Preferred Project Report (PPR)

Former Rachel Forster Hospital MP 09-0068
134-144 Pitt Street, Redfern

Submitted to
Department of Planning
On Behalf of Kaymet P/L

June 2013

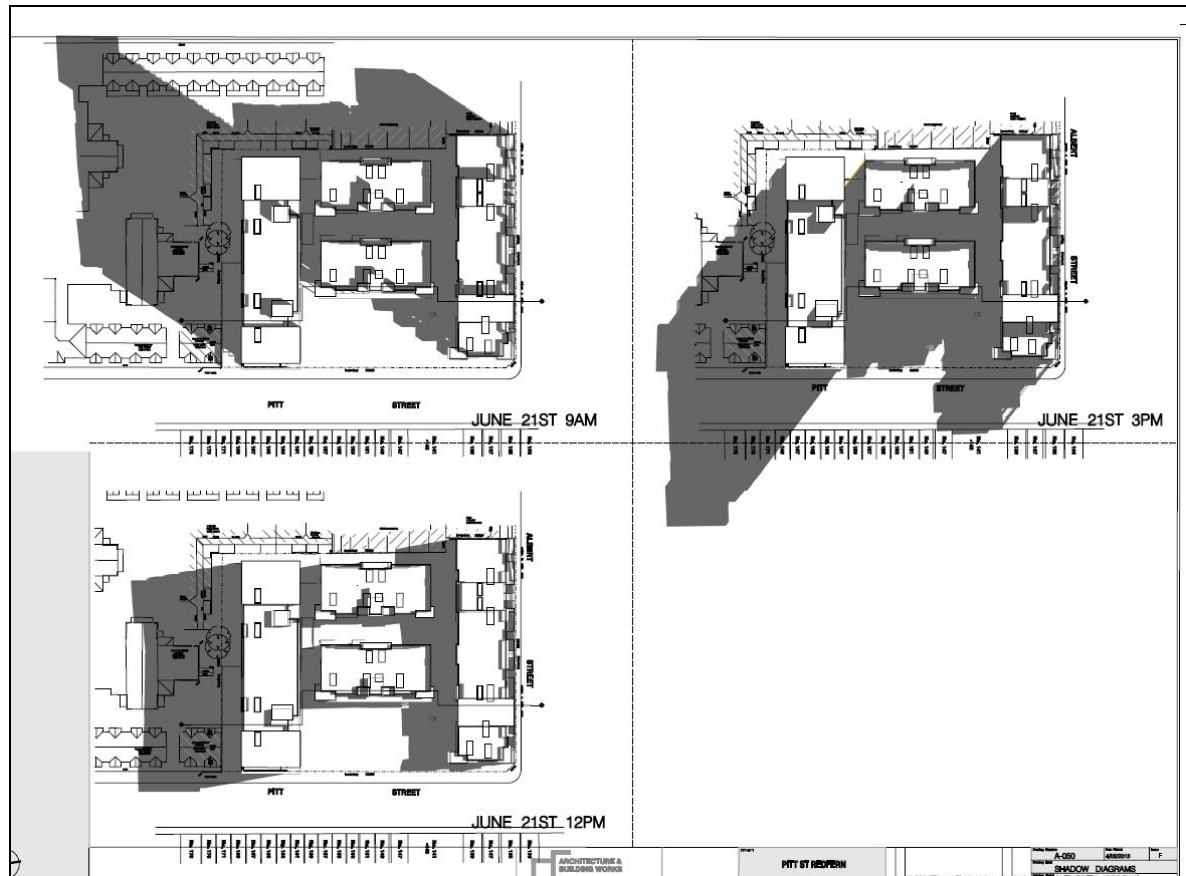
- Provide the additional documentation outlined in the City of Sydney submission in order to justify the additional height proposed on Building 1. Building footprints and cadastral information should be provided on shadow diagrams to properly determine impacts.

-The height on Building 1 has been reduced by 700mm thereby reducing any potential impacts.

*Lower ground floor landscape plan
Original Landscape Plan*

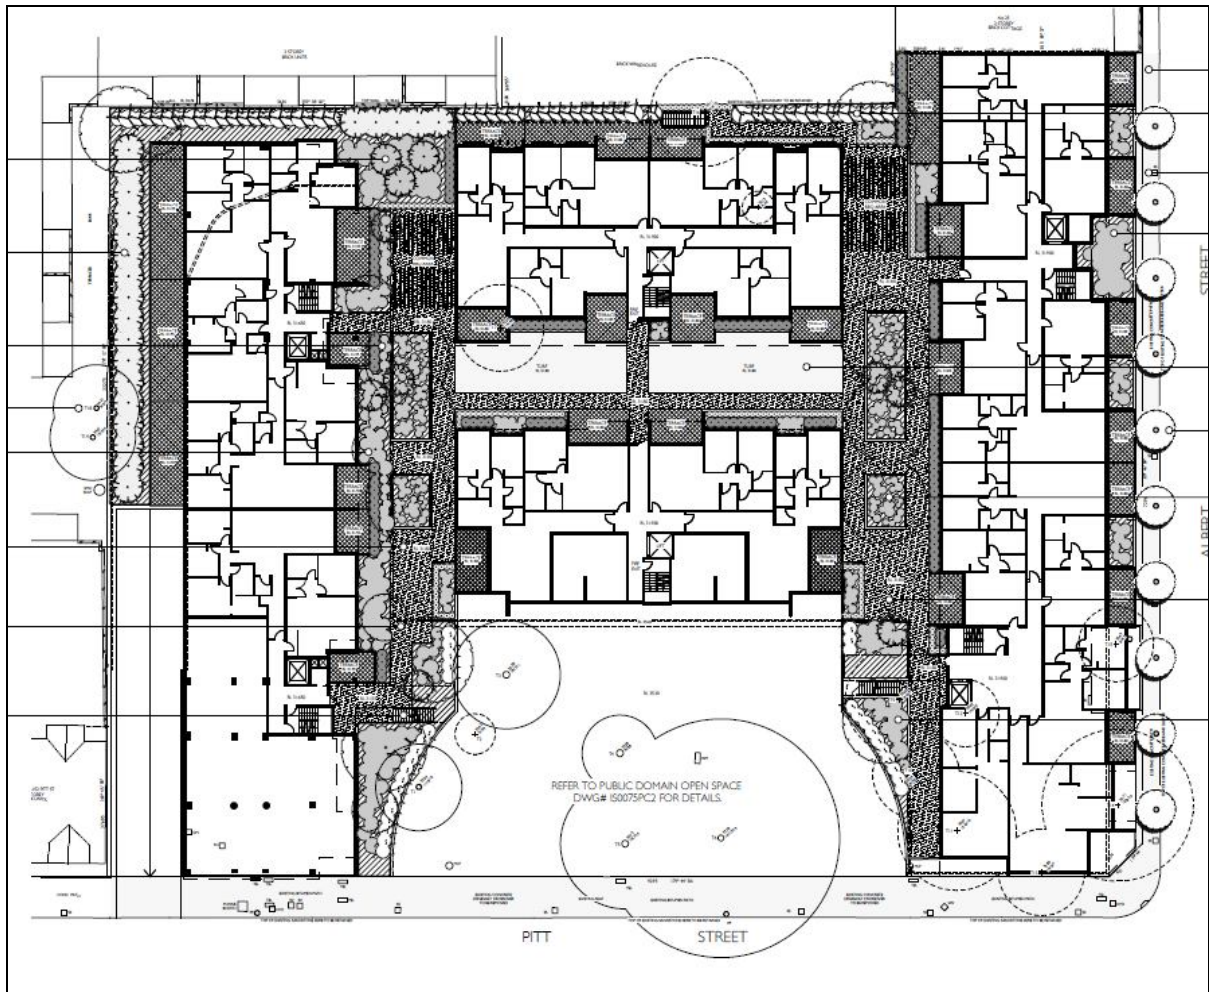
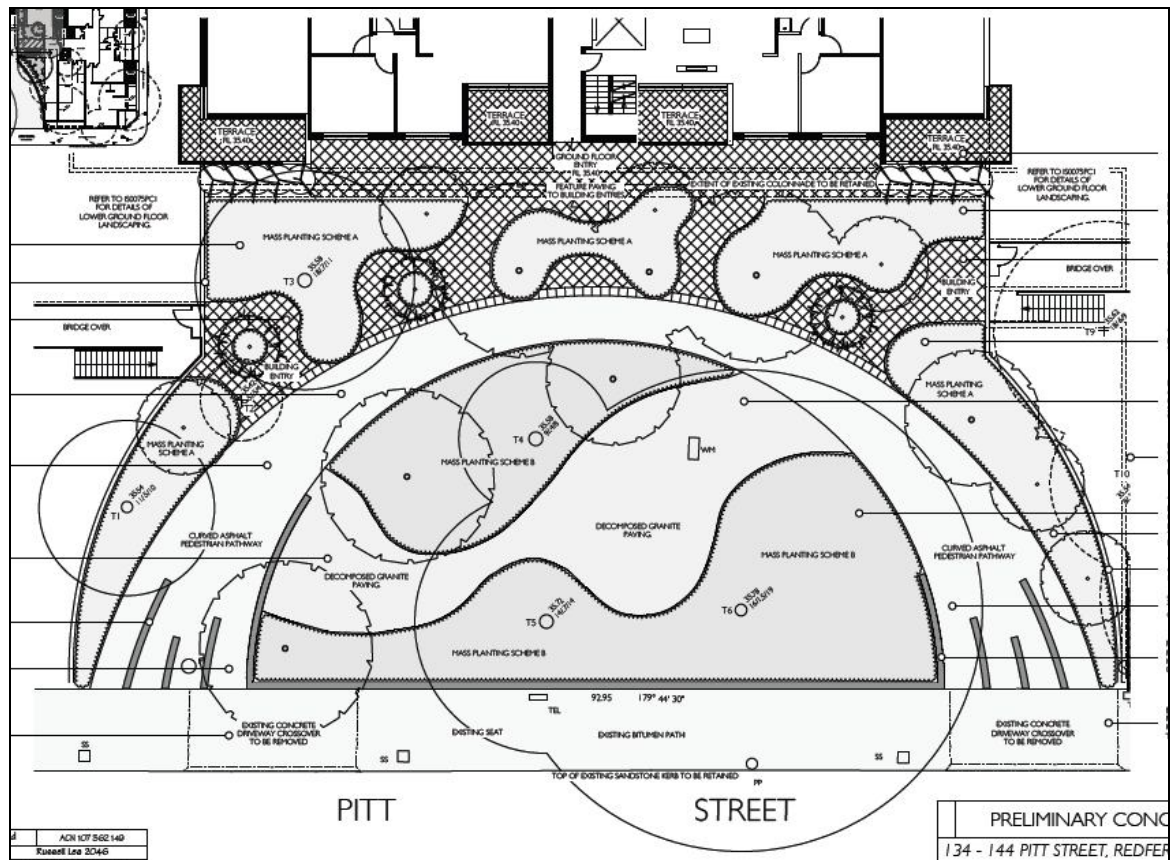
- Documentation needs to be provided outlining City of Sydney's agreement or otherwise of the dedication of the public open space fronting Pitt Street. Negotiation is required with City of Sydney regarding details of the design and also the final delegation of the area to be dedicated.

Response: The following response from Council was received which indicated that Council is not supportive of the dedication of land.

At this stage Council does not wish to pursue dedication of the land fronting Pitt Street, however public access (as required under the consent) is supported.

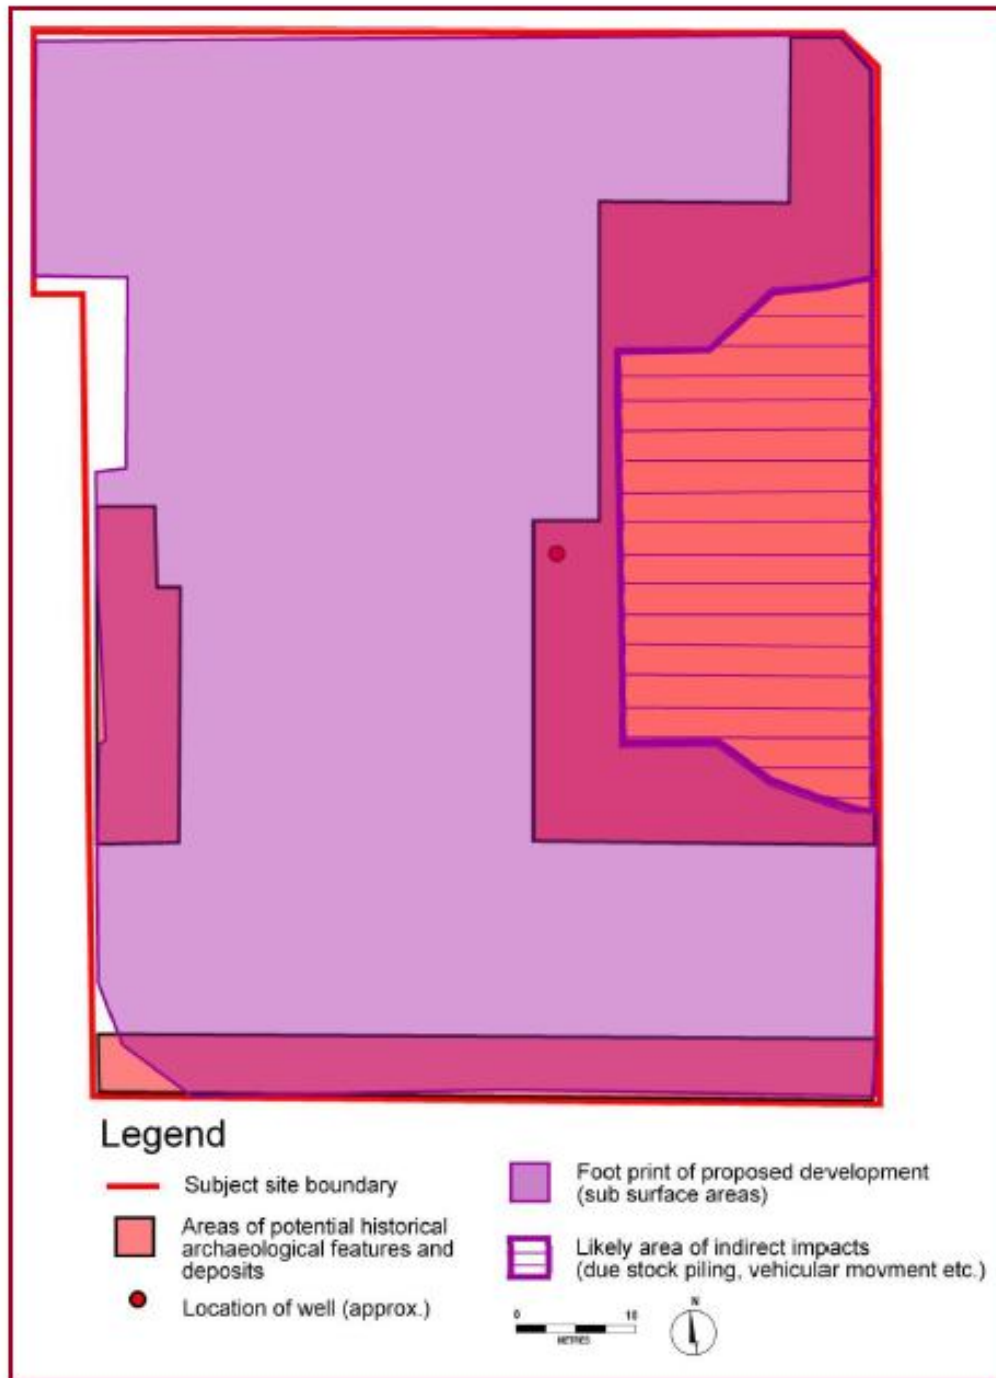
- The archaeological reporting process for this application is incomplete. Your attention is drawn to the recommendations of the report dated December 2012 by Archaeological & Heritage Management Solutions Pty Ltd forming part of your Environmental Assessment (EA), in particular the absence of consultation. The relevant assessment sections of the EA should also be updated following completion of this work.

The Archaeological Assessment dated December 2012 and the figure below demonstrates the extent of the area considered to have the potential to contain historical archaeological relics and/or Aboriginal sites (red shading). This area is primarily limited to the eastern frontage of the site and the eastern portion of the existing Building 2 between the main corridor in the basement and the front building wall. The legend in the figure below shows the location and extent of the well.

The only portion of the site that would be directly impacted by the construction of the proposed development is the area identified by the red lines in Map 2 of Figure 120. The balance of the area of archaeological potential (shaded red) is primarily limited to the eastern frontage of the site and will only be subject to superficial impacts as the majority of this area is proposed to be dedicated for public open space.

An updated Archaeology Report will be submitted to the Department of Planning and Infrastructure by 12 June 2013.
